***MAJOR PROJECT ASSESSMENT
Youth Hostel & Archaeological Education
Centre
110-128 CUMBERLAND ST, THE ROCKS
Proposed by YHA NSW Ltd
MP06_0265***

Director-General's Environmental Assessment
Report
Section 75I of the
Environmental Planning and Assessment Act 1979

December 2007

Figure 10 – Building envelope controls under SCRA Scheme

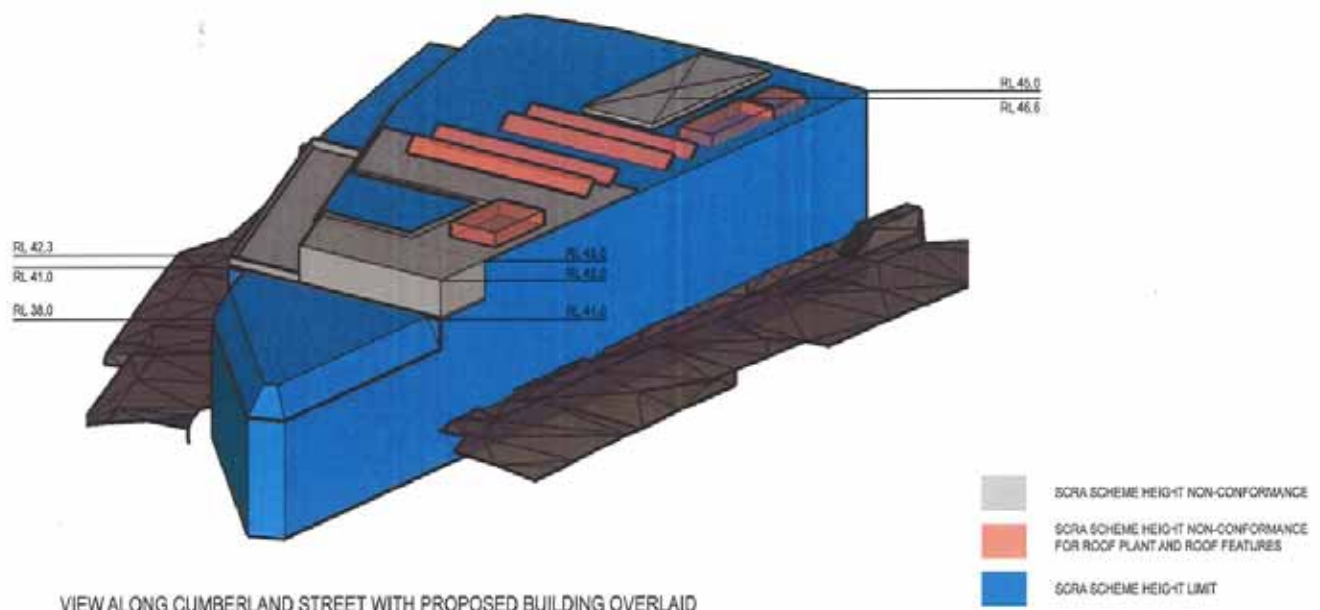
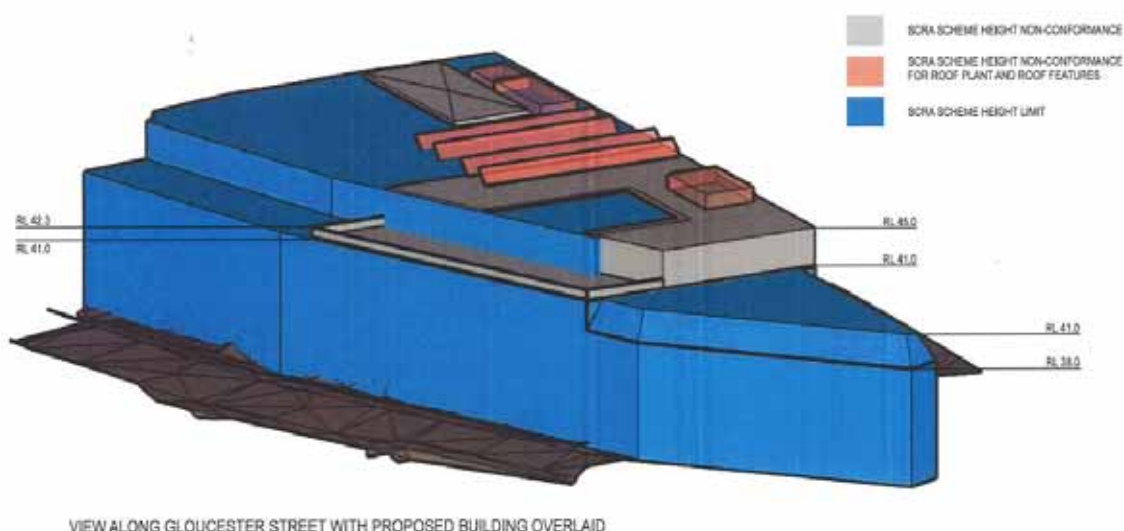
The proposed building envelope variation is specific to the height of the building at the northern and north-eastern elevations, and roof top features. The Building Site Control Drawing No. XXXIV(1) depicts the maximum permissible building envelope on the site. The building envelope steps back from a height of RL 41 at Gloucester Street to a maximum height of RL 45. A note on the Key map provides that 'small projections such as flagpoles may be approved above the building envelopes'.

The subject proposal seeks a building form which is not consistent with the envelope controls or the overall height control. The proposal has been designed in a manner which exceeds these controls due to an elevated roof form over a void area, roof top plant rooms, roof top solar collectors and elevated vent structures. The building is further heightened due to the need to design the proposal above the archaeological remnants. The extent of the non-compliance, in relation to the maximum controls, is illustrated in Figure 10.

Overall it is considered that the application to vary the SCRA Scheme adequately describes the draft variation, the reasons for variation, its likely impact (which is considered to be minor), and its compliance with the general planning and design principles of the SCRA Scheme. The proposed variation is therefore supported.

Figure 11 – proposed parking arrangements

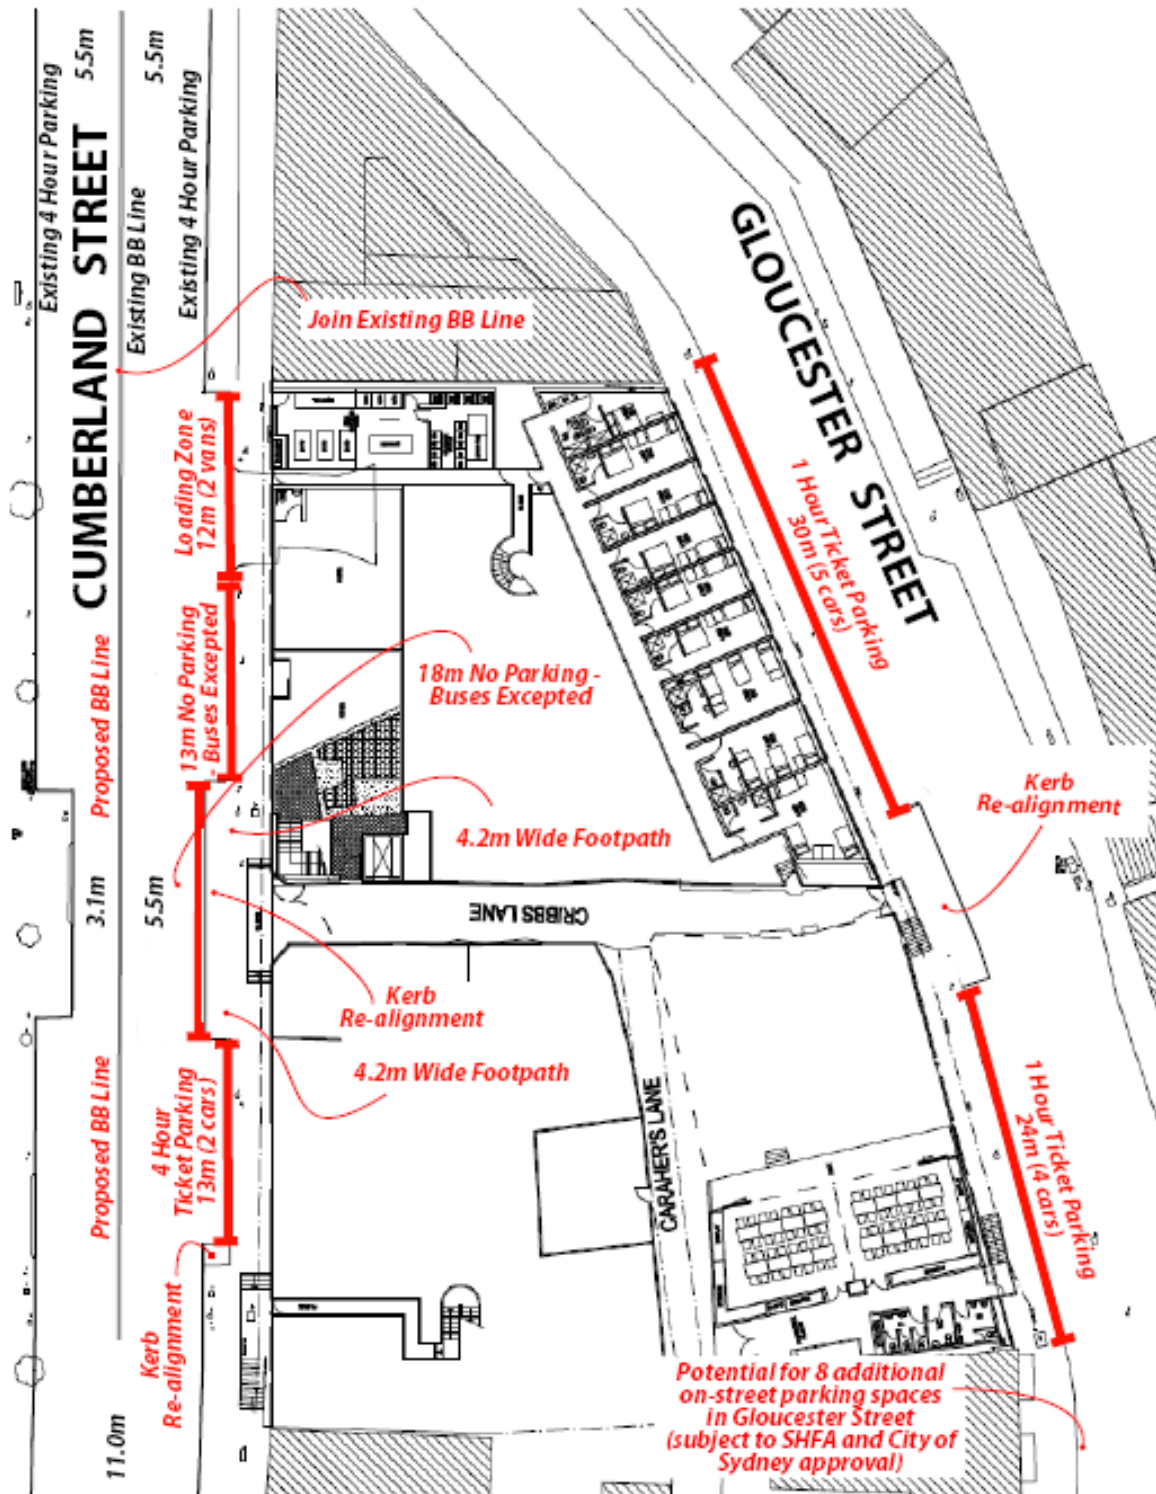
The proponent's traffic assessment report recommends that provision be made for on-street bus parking. A 13 metre long bay is proposed along Cumberland Street which would service the hostel and education centre needs, and revert to residential parallel car parking spaces in the evening until early morning. An additional 18 metre coach/bus drop off zone is proposed alongside the kerb realignment on Cumberland Street, directly outside the entry to the hostel (see Figure 11).

The City of Sydney Council is generally supportive of the proposed parking arrangements for the development. The proposal was put forward for recommendation to the Sydney Traffic Committee at its meeting on 19 December 2007. The Committee considered the proposed bus parking arrangements favourably and recommended that the City of Sydney's Traffic Engineer signpost residential parking hours and advise the proponent.
